**Appendix A:  
NOP Public Comment Letters**

**From:** Mario Suarez <msuarez@coltonca.gov>  
**Sent:** Wednesday, February 12, 2025 1:55 PM  
**To:** Alison Rondone <arondone@fcs-intl.com>; Alex So <aso@urbanxroads.com>  
**Subject:** FW: Housing Element Program 10 & 11 General Plan Amendment and Rezone - SCH 2025010520

**Re: 2025010520 Housing Element Program 10 & 11 General Plan Amendment and Rezone Project, San Bernardino County**

**DWR Manhole Structure**

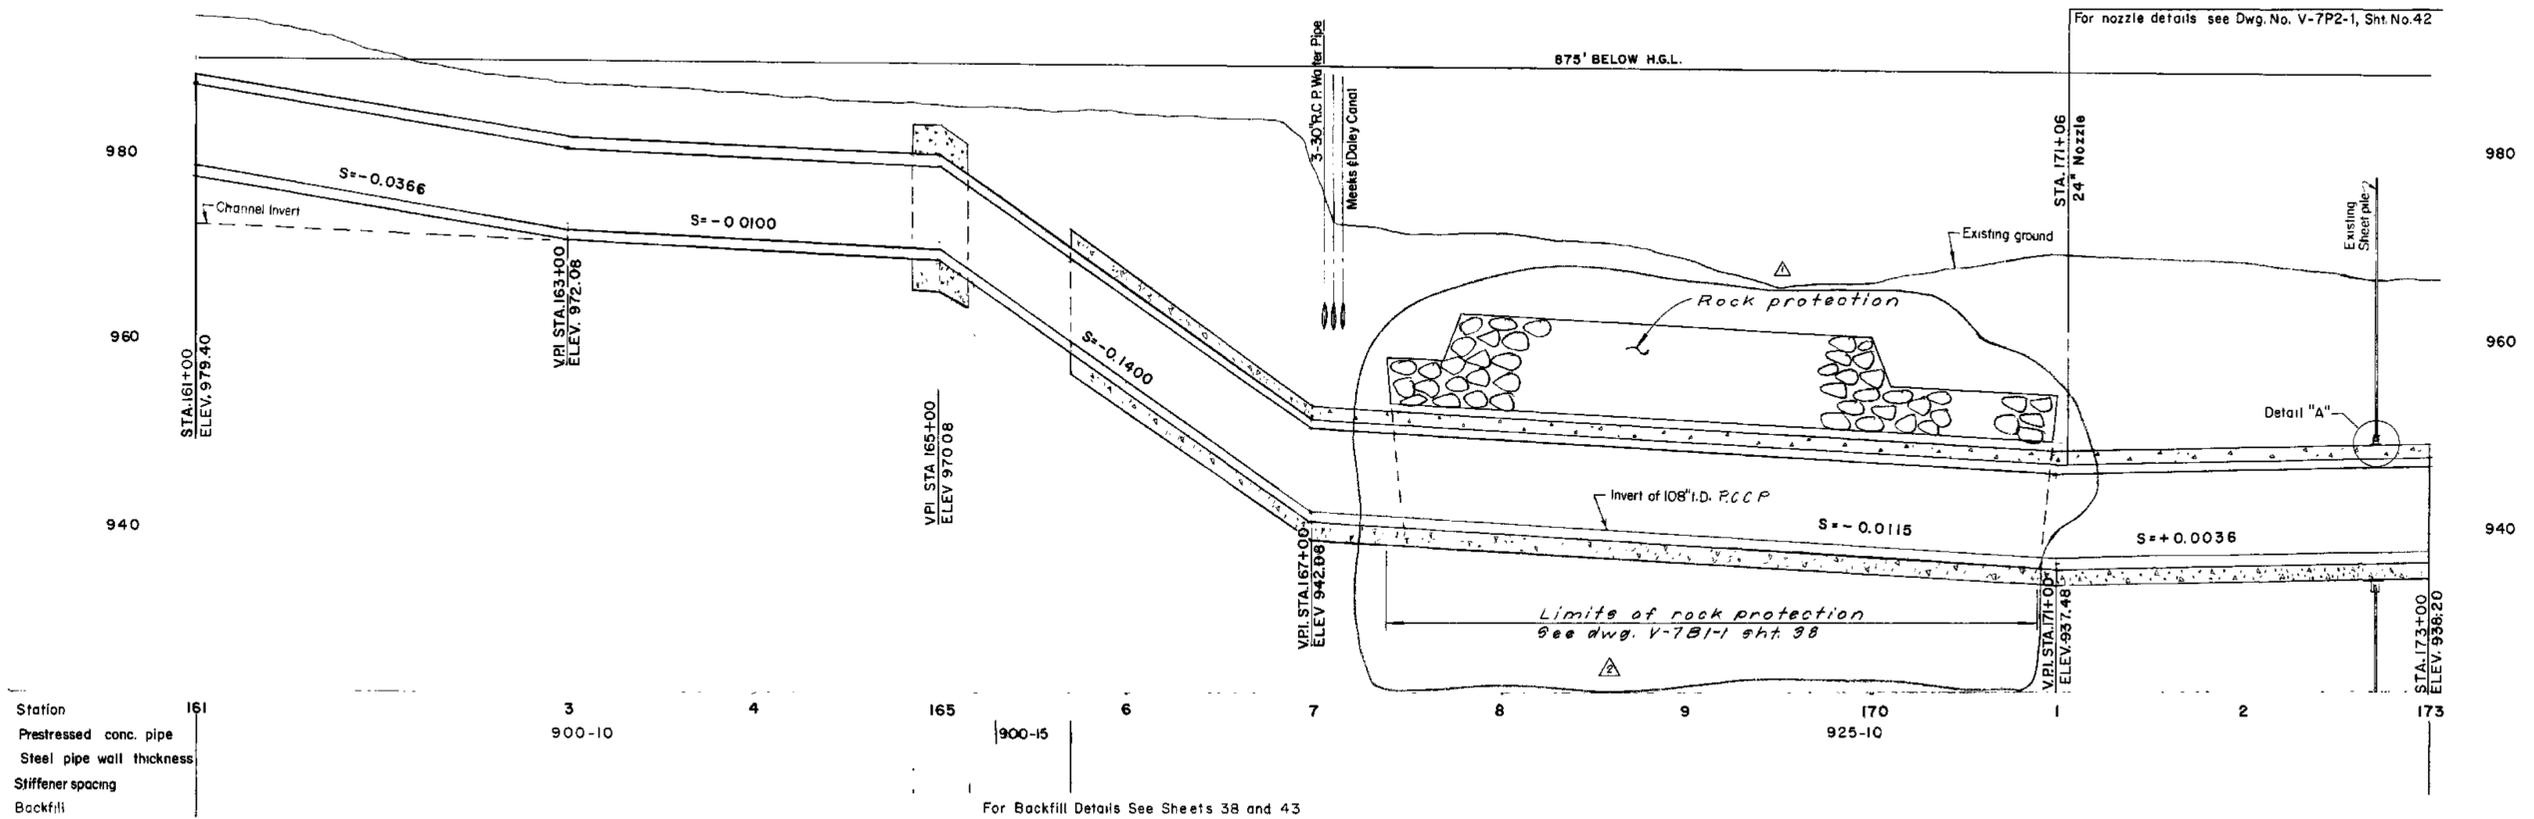
The Assessor's Parcel Numbers for Area 4 and 5 shown in Tables 1 & 4 Potential Sites for Rezone under Program 10/11 Rezone/GPA do not match Exhibit 6. Please identify the correct parcel and update the information accordingly.

In addition, please add to Exhibit 2, Exhibit 3 all DWR facilities listed above,

is required to be free of encumbrances that may impact DWR facilities. Under those regulations, improvements within DWR right of way are limited to a greenbelt area or the equivalent. No permanent structures are allowed within DWR right of way. Any improvements proposed within DWR right of way will need to acquire an encroachment permit from DWR. The proposed design plans for parcel numbers including 0164-28-101, 0164-28-102, 0164-18-108, 0164-18-251, 0164-18-248 (shown on Exhibit 6 of NOP) may need to be revised or modified to accommodate DWR right of way where the pipeline crosses through these parcels. All DWR facilities listed above shall be protected in place and will not be relocated or removed for the proposed parcels.
